BOARD OF APPEALS

- A. **2026-0005 V-25-53 - 870 Edgewater Drive** — Request for a Variance from Sec. 6.1.2.B. to encroach into the 60-foot primary street setback by 20 feet for a new home.
(Presented by: Michele McIntosh-Ross, Planning & Zoning Manager)

P&Z STAFF REPORT

Case: **V-25-53 – 870 Edgewater Drive**
 Staff Contact: Helen Owens (howens@sandyspringsga.gov)
 Report Date: January 21, 2026

Site Plan (received December 19, 2025)

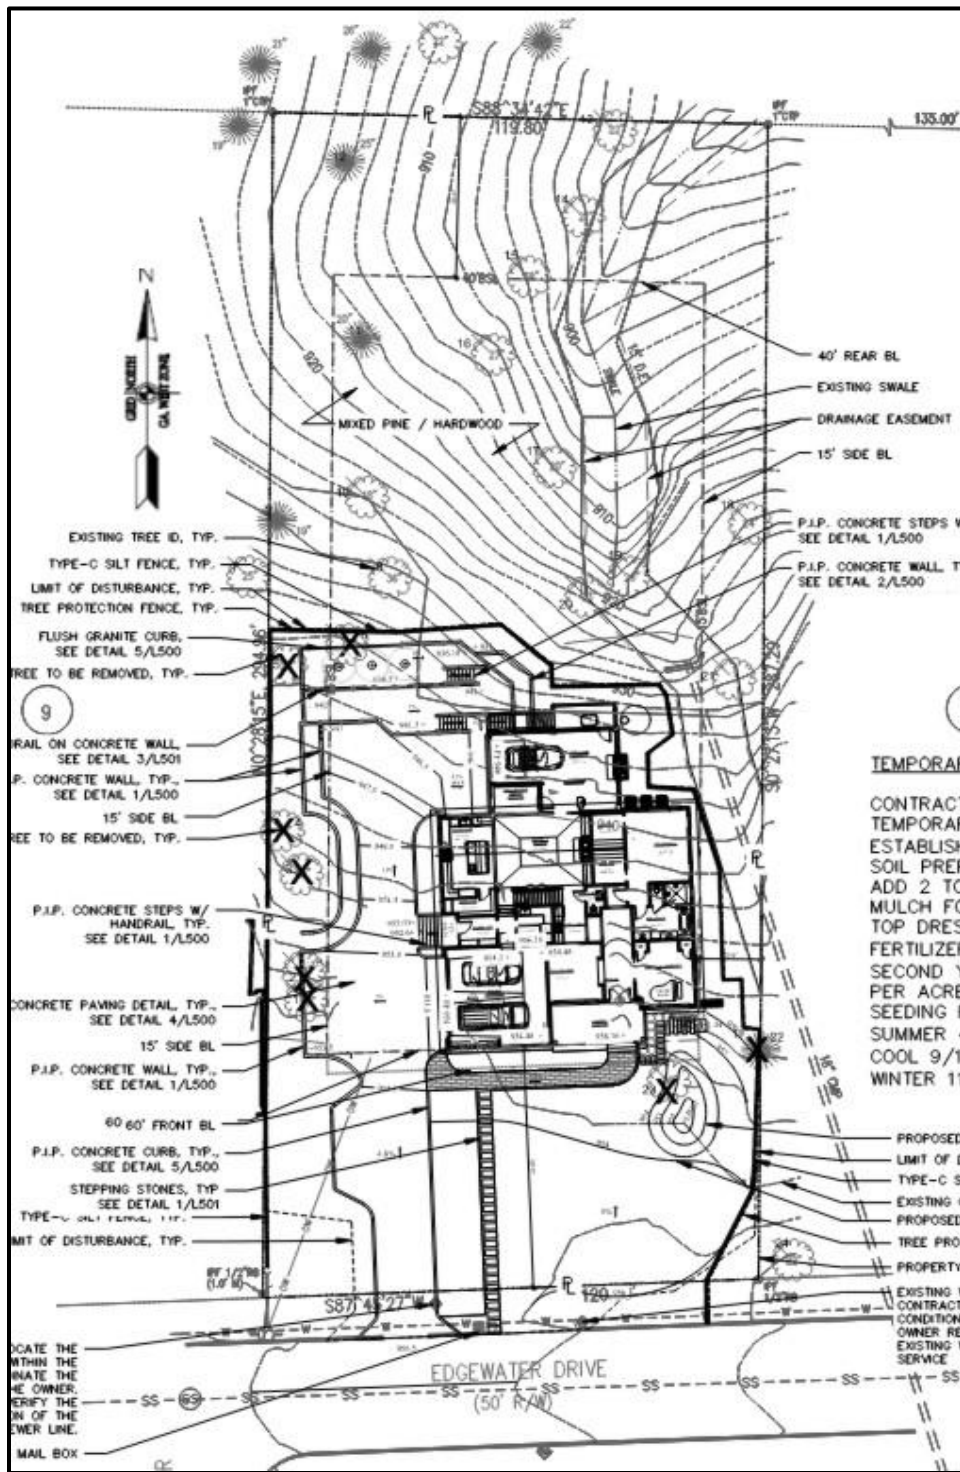
The applicants are proposing to build a new home that encroaches into the 60-foot primary street setback by 20 feet.

Above is a code compliant alternative design the applicants provided. All the site elements are located within the buildable area

I reviewed the preferred site plan and the site plan included in the MRPA review document, which shows the proposed house within the buildable area. The claim that the tree impacts will be greater with the house located within the buildable area cannot be verified as the critical root zone impacts were not shown by the applicant.

The other houses on that side of the street align with the front of the current house on 870 Edgewater or they are set even farther back. The deck structure will need to be designed and stamped by a structural engineer (licensed in the State of Georgia.). Note that if the variance is granted you will still need to submit a complete set of drawings (Civil, Architectural, Structural (if applicable) and Engineered Wood Products layouts (if applicable) and go through plan review to obtain a Building Permit. They could eliminate the golf cart parking garage and reduce the encroachment into the front setback by as much as 10 feet.

On the alternative plan the walls appear to meet code as they are interior facing and do not exceed the height requirements. The applicant will need to apply for all the necessary building permits.

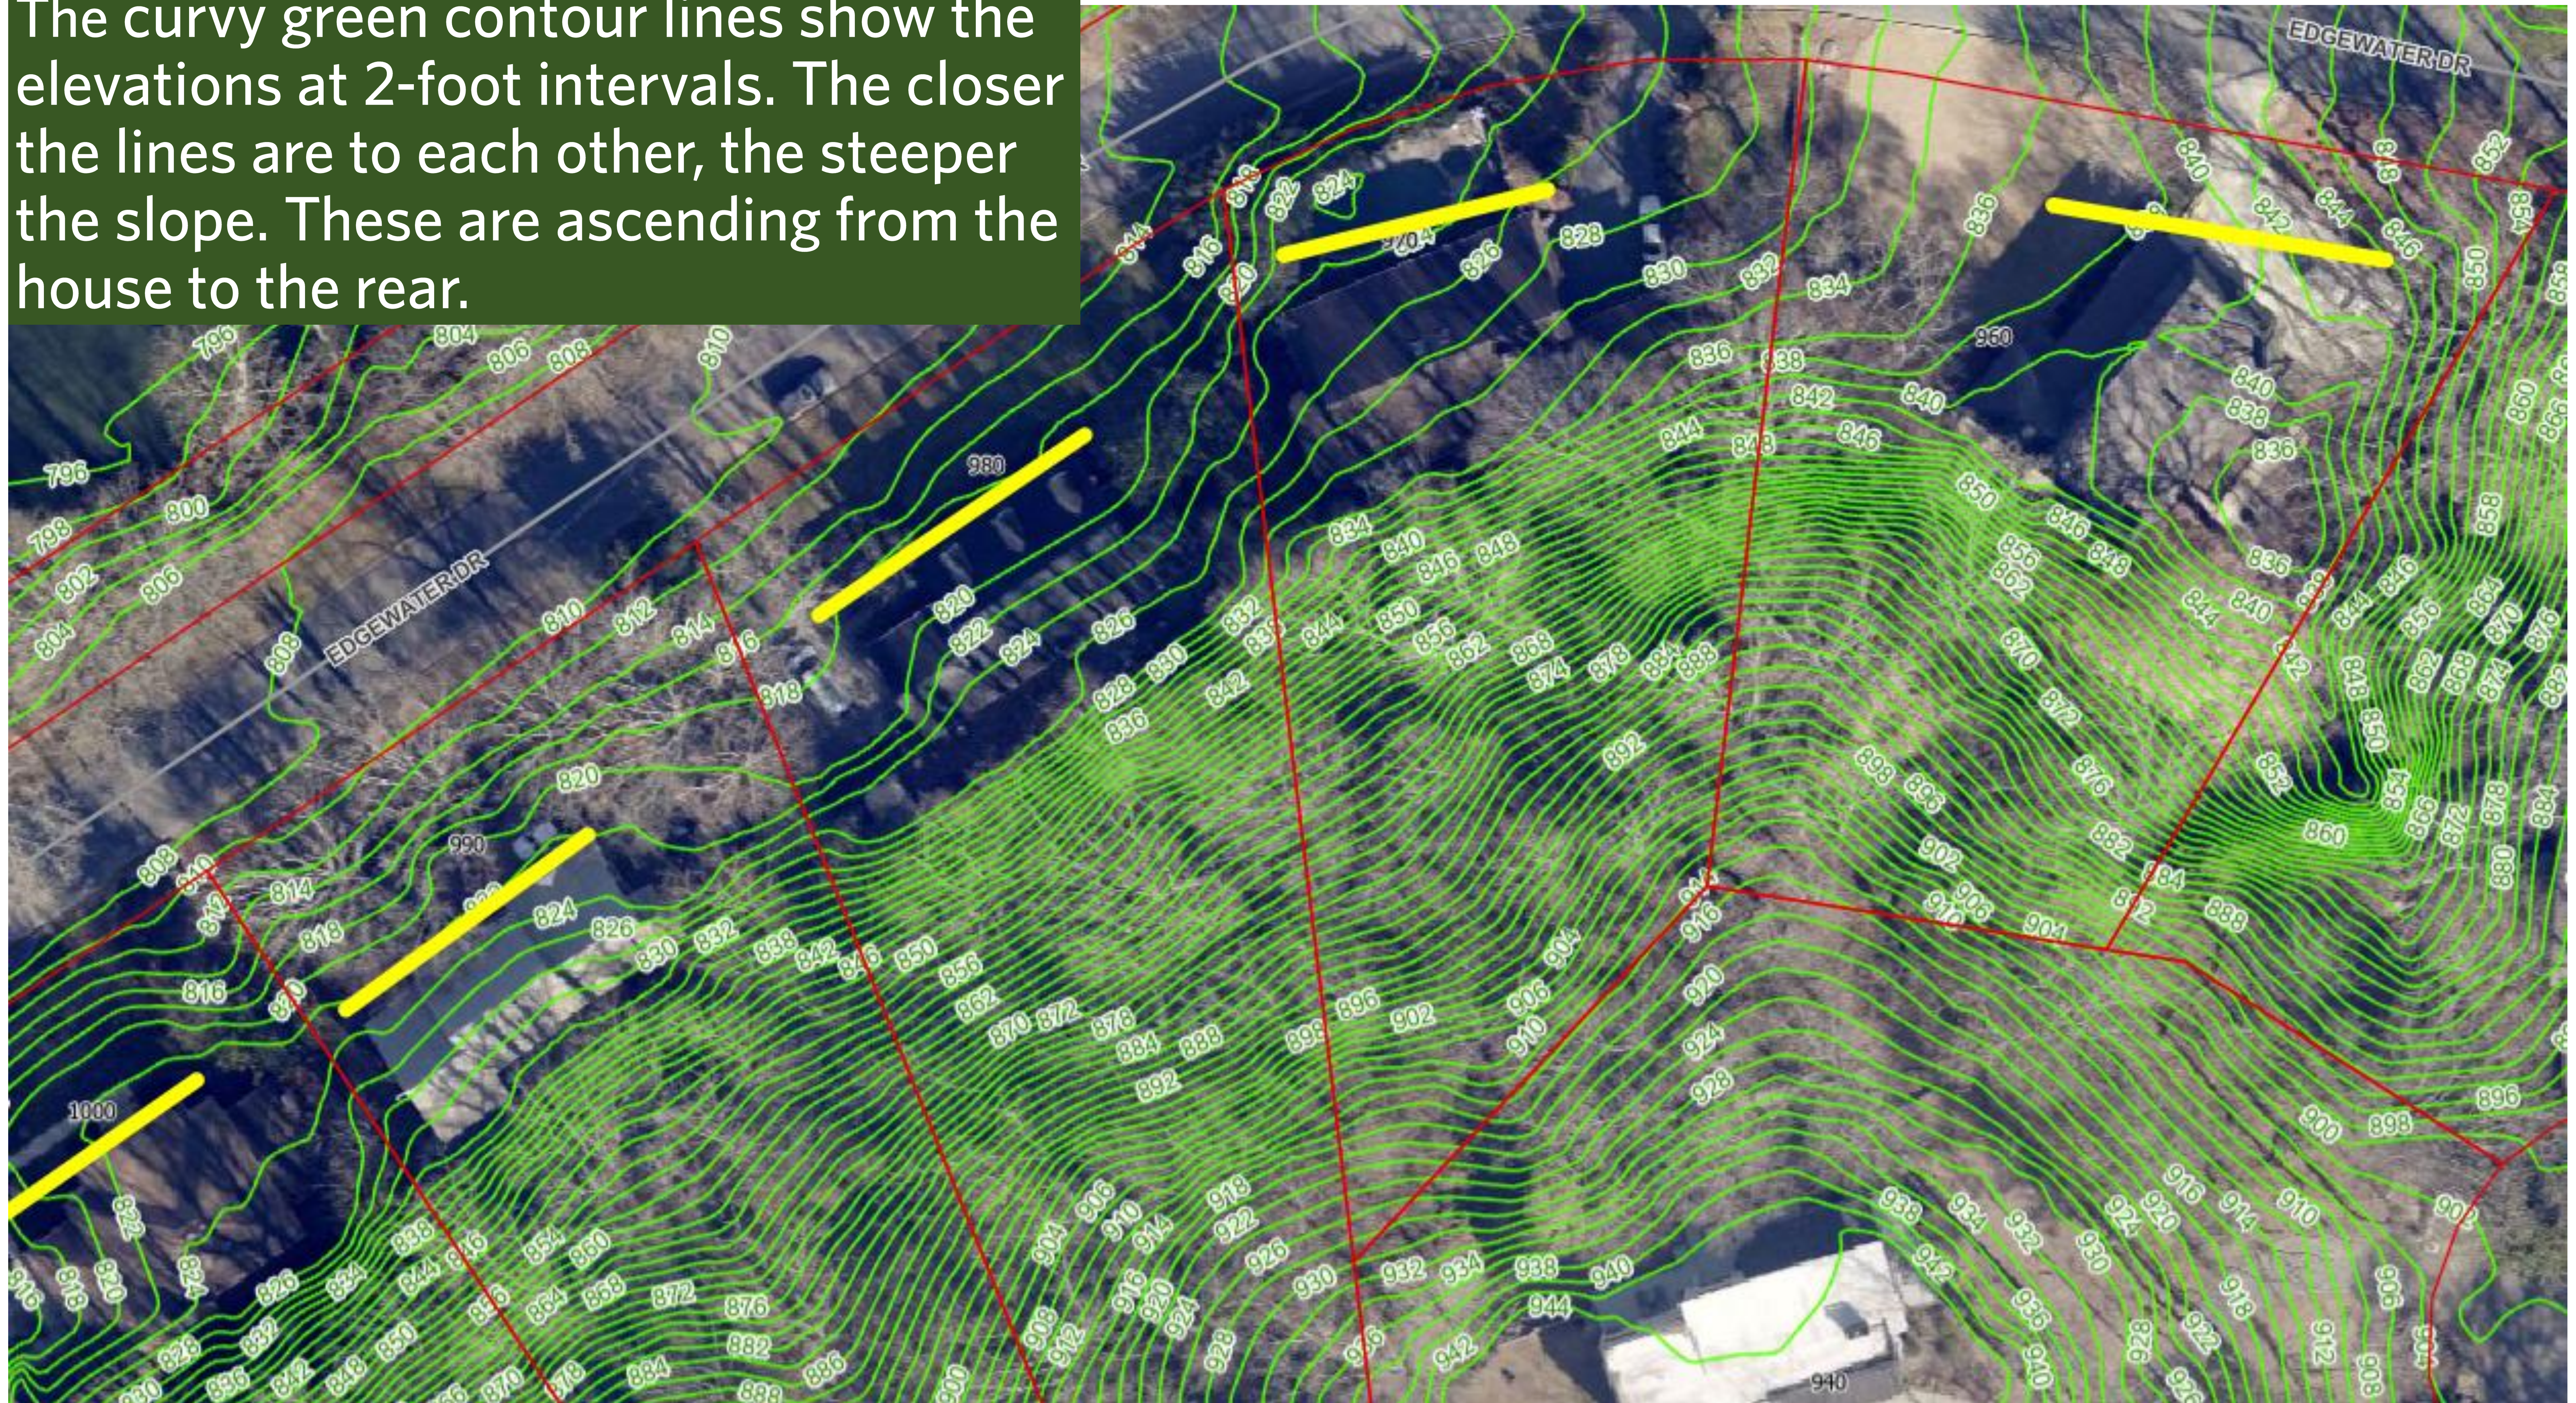
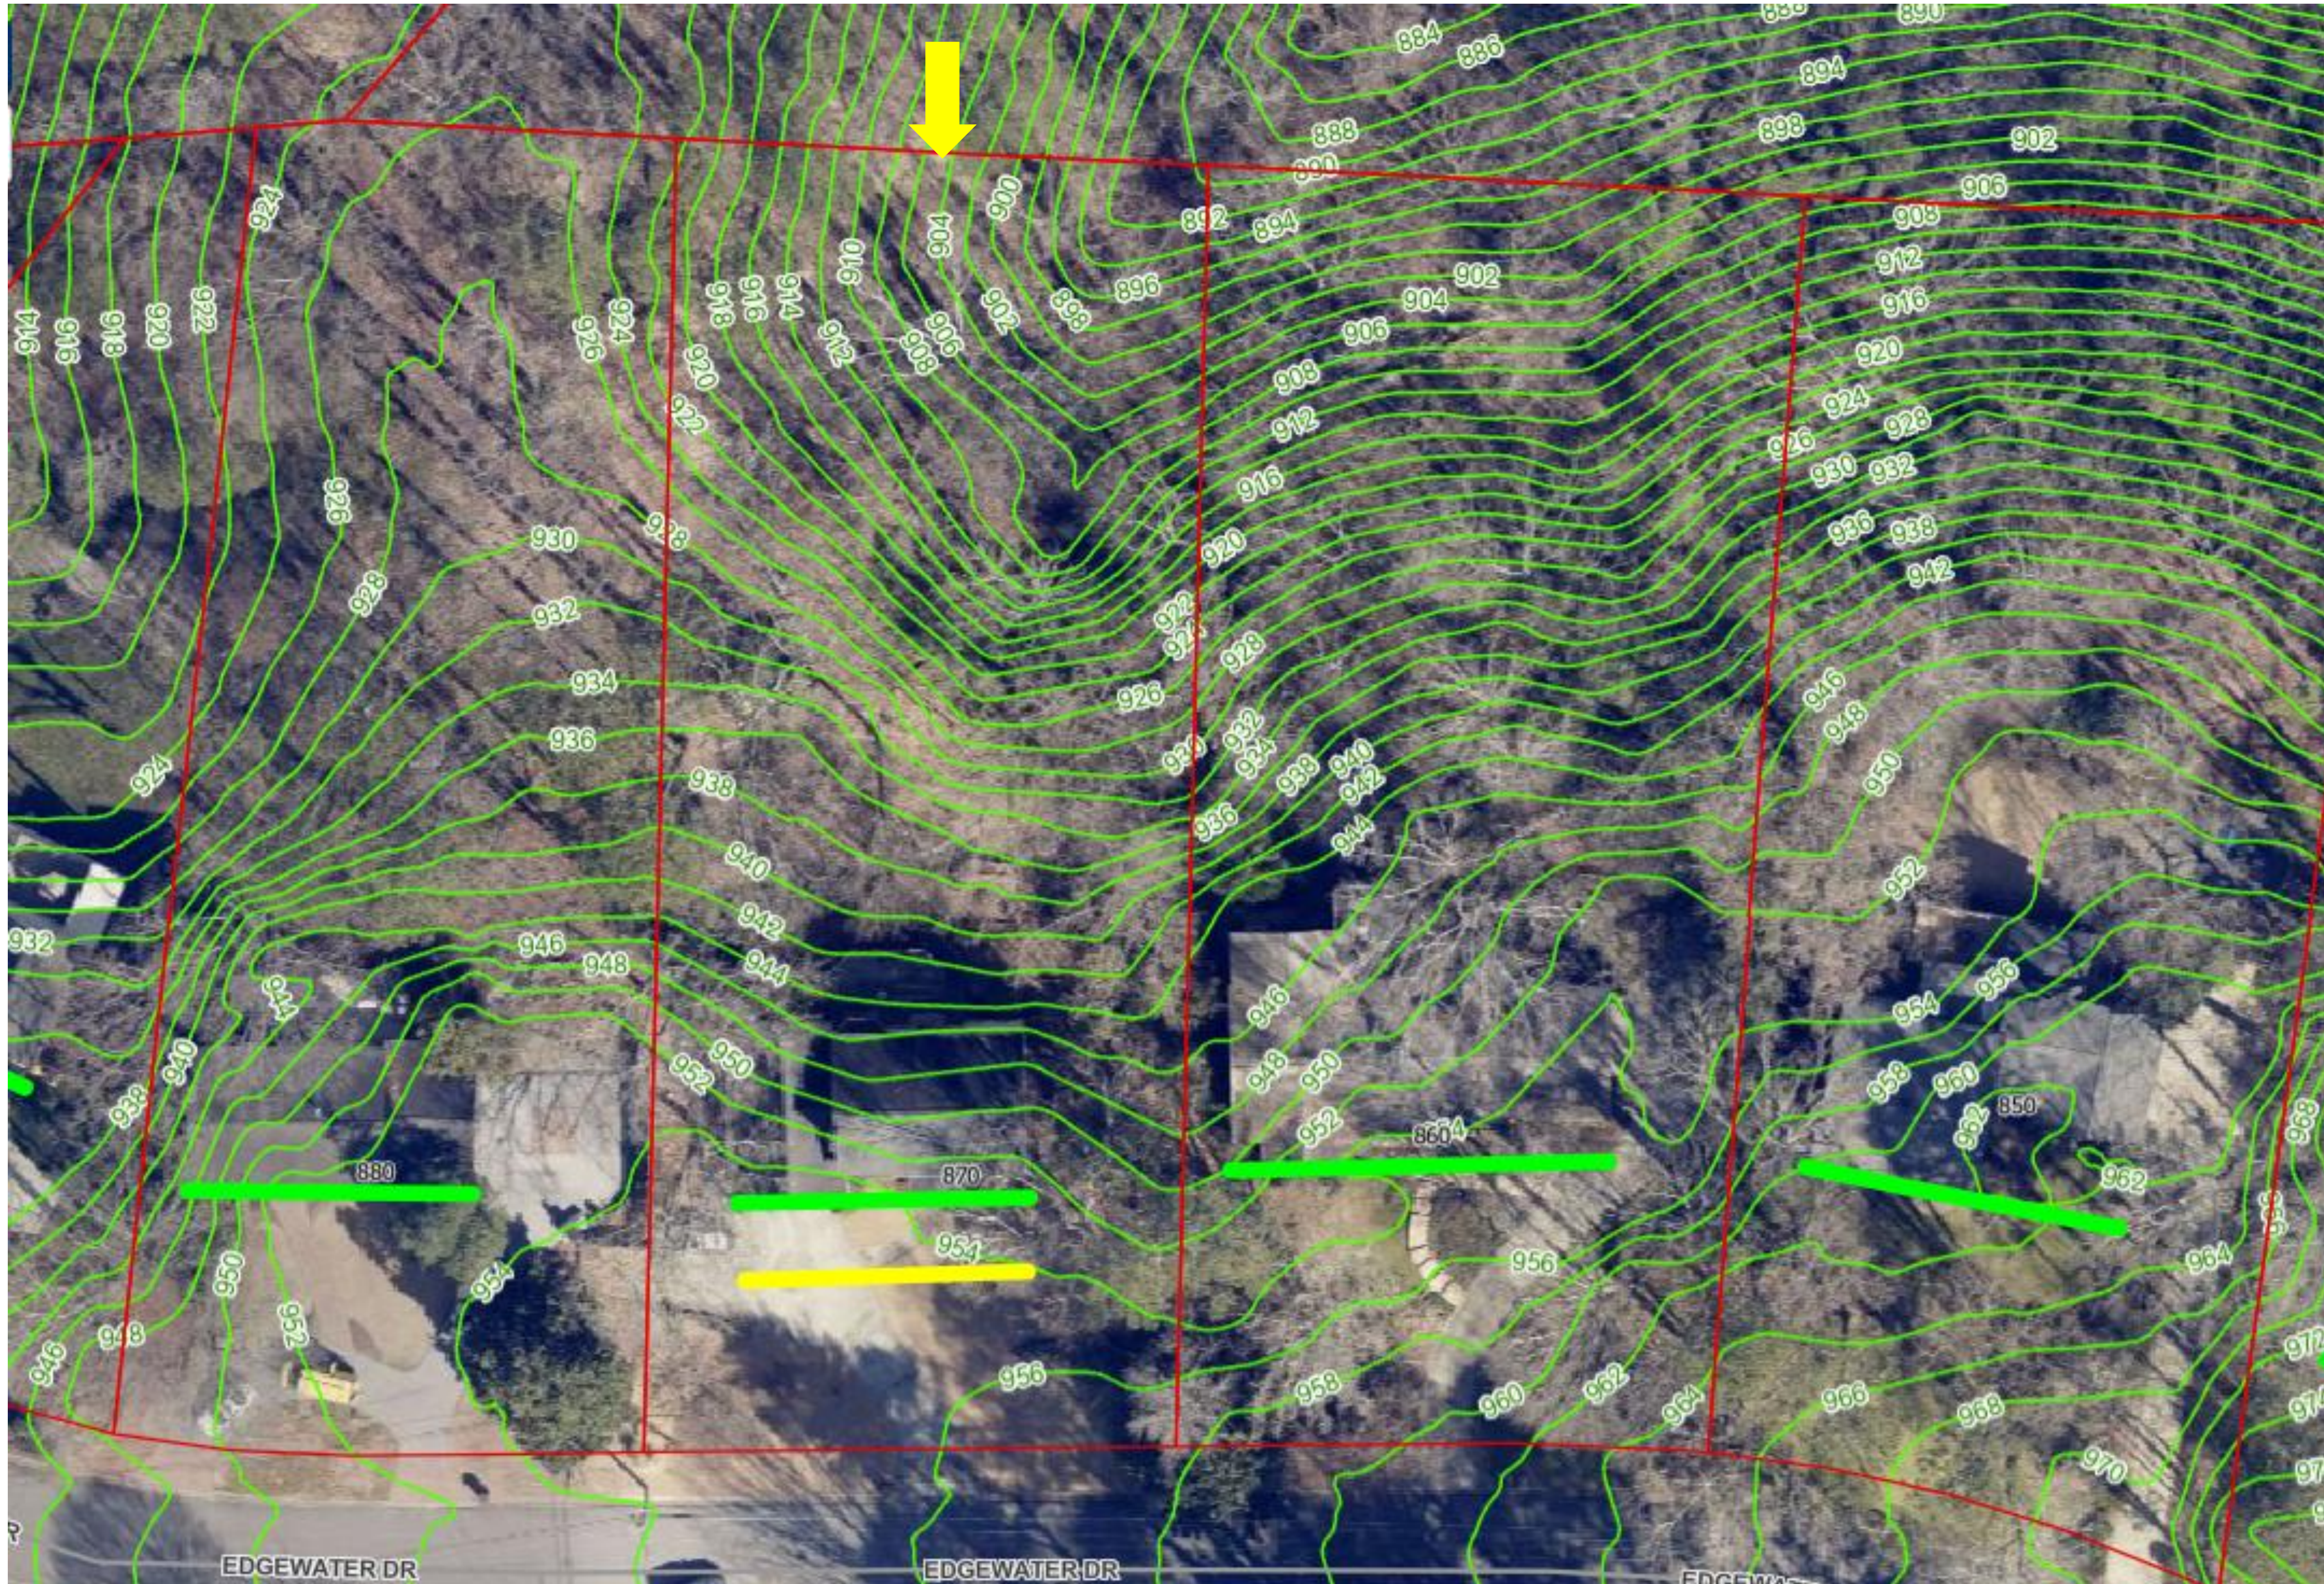
The green lines indicate the existing front planes of the homes at the 60-foot primary street setback along Edgewater Drive.

The green lines indicate the existing front planes of the homes at the 60-foot primary street setback along Edgewater Drive. The yellow line indicates the proposed 20-foot encroachment into the primary street setback.

The green lines indicate the existing front planes of the homes at the 60-foot primary street setback along Edgewater Drive. The yellow line indicates the proposed 20-foot encroachment into the primary street setback.

The green lines indicate the existing front planes of the homes at the 60-foot primary street setback along Edgewater Drive. The yellow lines indicates the encroachment into the primary street setback.
